# Proposed Reference Equalizer Change in Clause 122.8.5.4 and Test Pattern Change in Table 122-15

Xianxu Peng, Shaoyun Yi, and Winston Way  
*NeoPhotonics*

# BER versus OMA

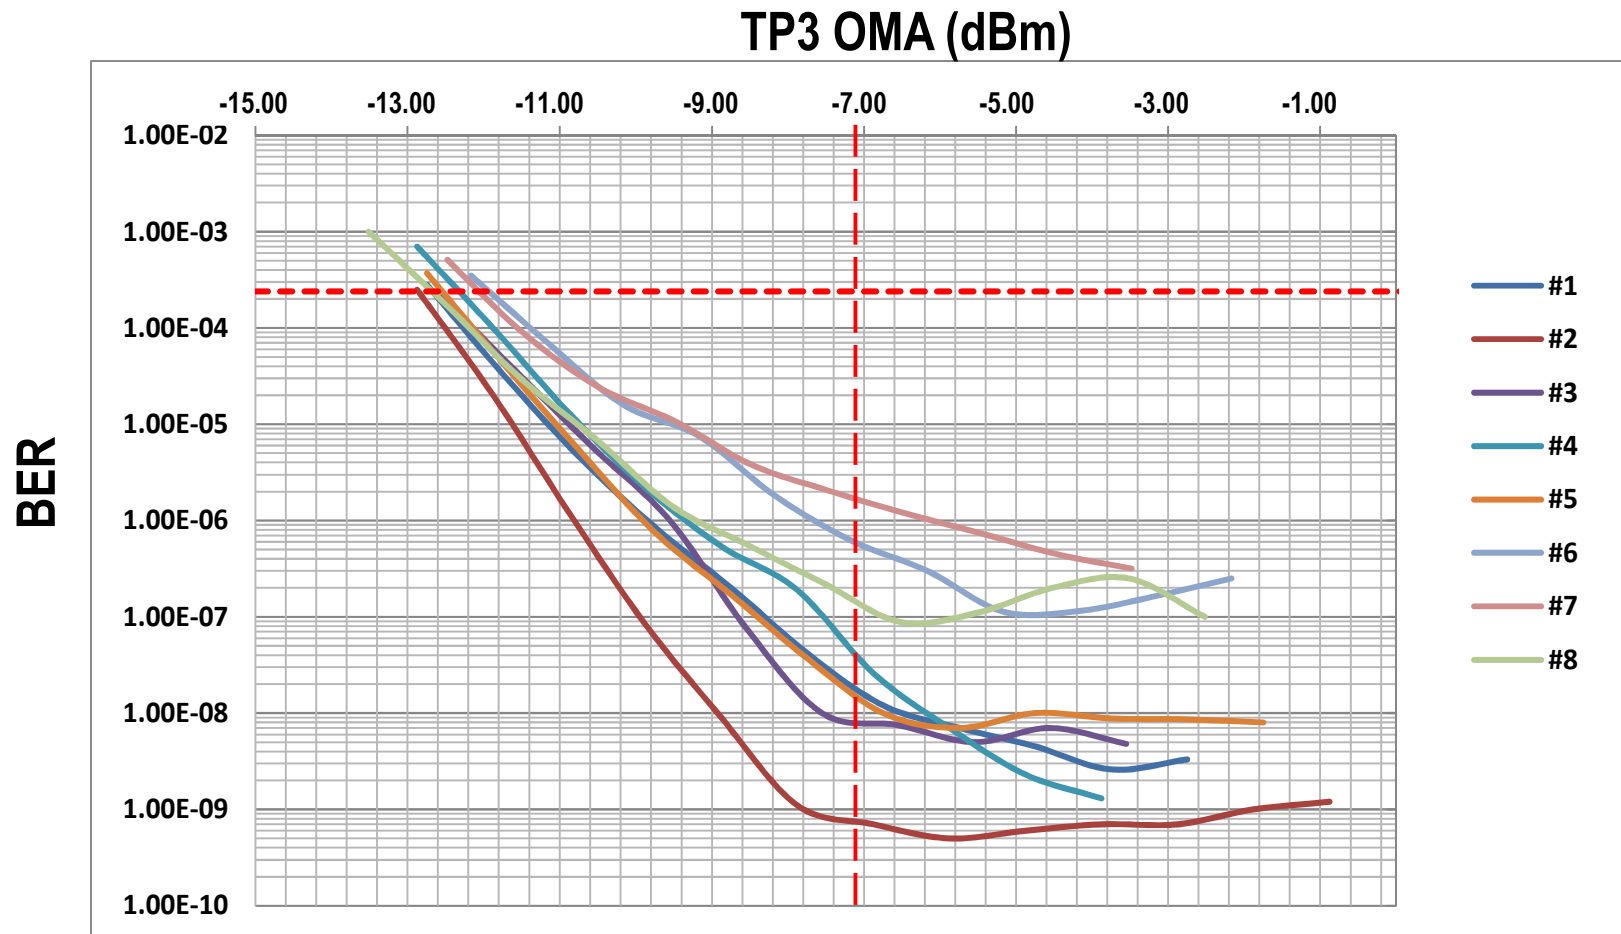
- Test results of 8 individual lanes – All pass with sufficient BER and OMA margin
